Form 3160-5
(June 2019)UNITED STATES
DEPARTMENT OF THE INTERIOR
BUREAU OF LAND MANAGEMENTFORM APPROVED
OMB No. 1004-0137
Expires: October 31, 2021**SUNDRY NOTICES AND REPORTS ON WELLS**
Do not use this form for proposals to drill or to re-enter an abandoned well. Use Form 3160-3 (APD) for such proposals.5. Lease Serial No. **NMNM108971**

8. Well Name and No. **JEFE 29 FED COM/707H**9. API Well No. **30-025-48850**10. Field and Pool or Exploratory Area
WC-025 G-07 S253216D; UPPER WOLFCAMP11. Country or Parish, State
LEA/NM**12. CHECK THE APPROPRIATE BOX(ES) TO INDICATE NATURE OF NOTICE, REPORT OR OTHER DATA**

EOG respectfully requests an amendment to our approved APD for this well to reflect the following changes:

Revised Permit Information 08/22/2022:

Proposed Wellbore

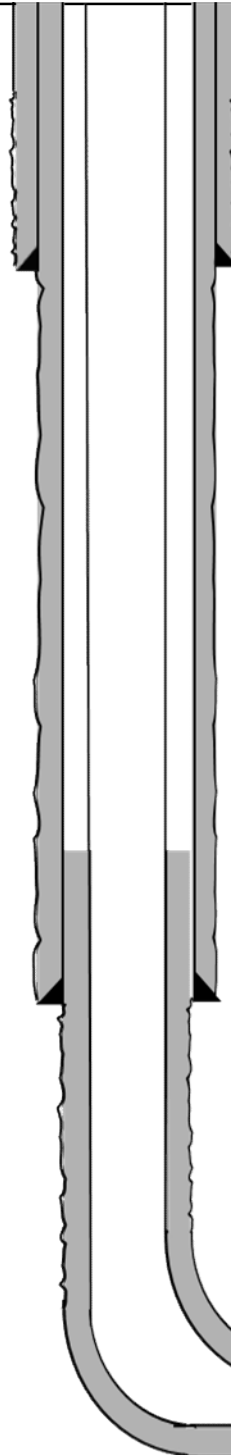
Change name from 707H to Jefe 29 Fed Com 737H.

Change target formation to Wolfcamp U3.

Update casing and cement program to current design.

Design B**4. CASING PROGRAM**

Bit Size: 13"
10-3/4", 40.5#, J-55, STC,
@ 0' - 1,190'

Bit Size: 9-7/8"
8-3/4" 38.5#, P110-EC, Vam Sprint-SF,
@ 0' - 10,937'

Bit Size: 7-7/8"
6", 24.5#, P110-EC, DWC/C IS,
@ 0' - 11,875'
5-1/2", 20#, P110-EC, DWC/C IS MS,
@ 11,875' - 19,912'

Figure 3: Back Yard Rig Up

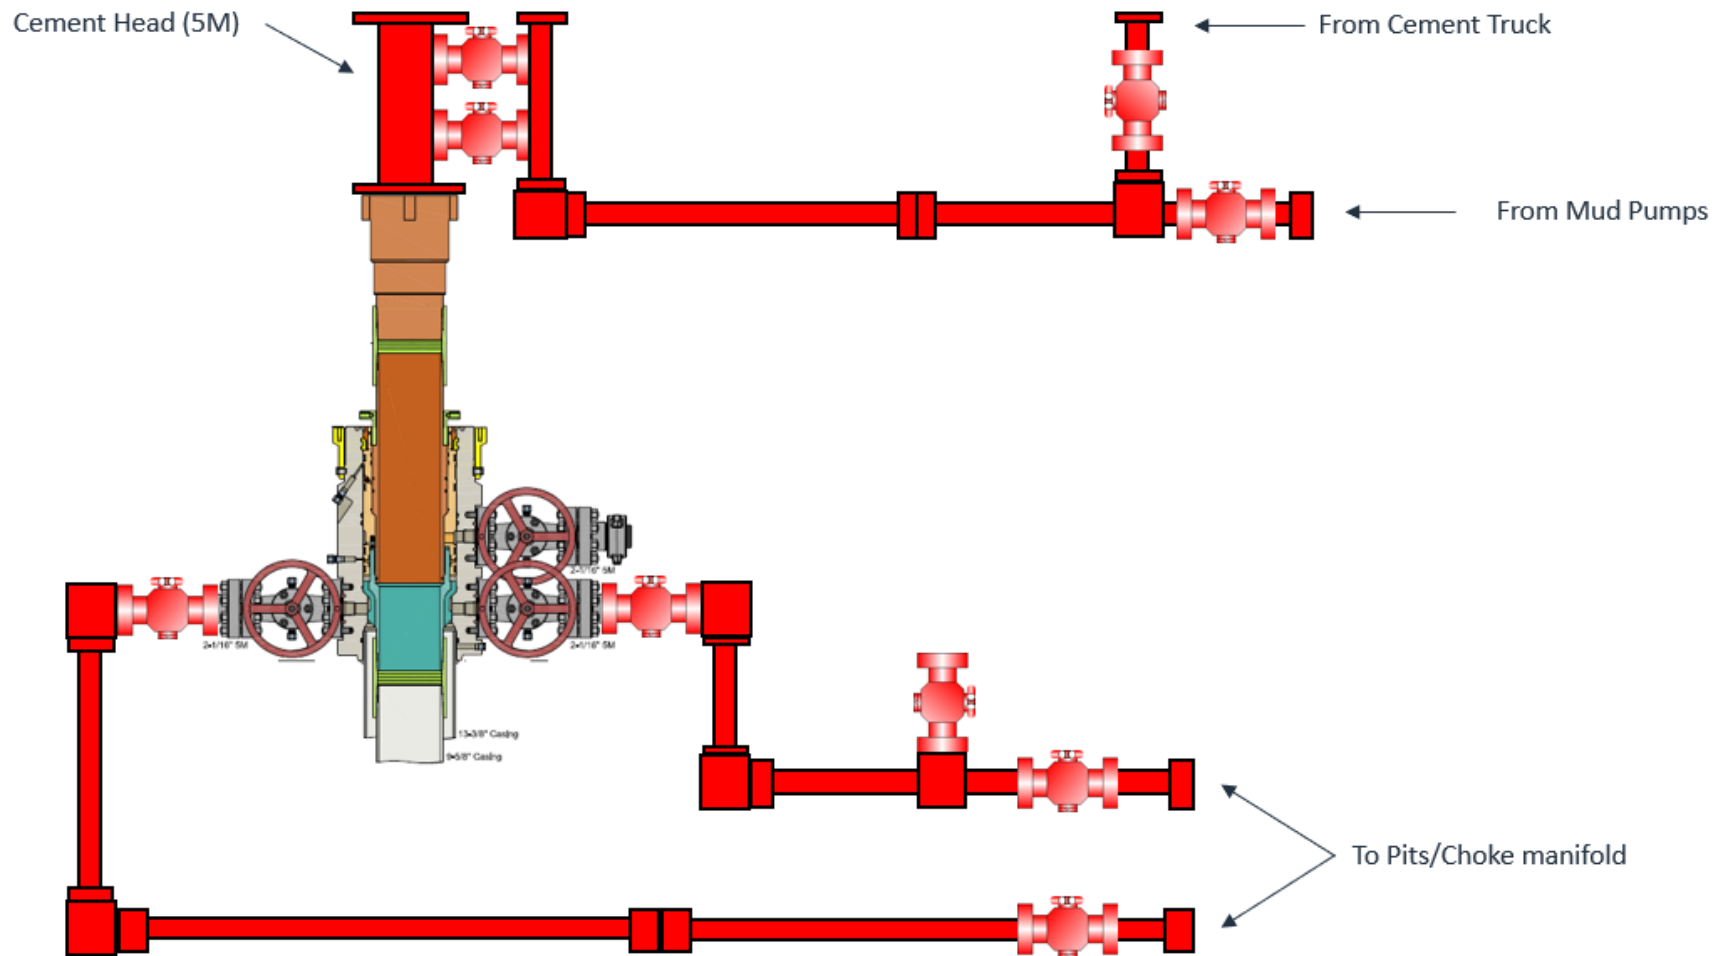
- c. Return line schematics can be seen in Figure 3.
10. Remove TA Plug from the casing.
11. Install offline cement tool.
 - a. Current offline cement tool schematics can be seen in Figure 1 (Cameron) and Figure 2 (Cactus).
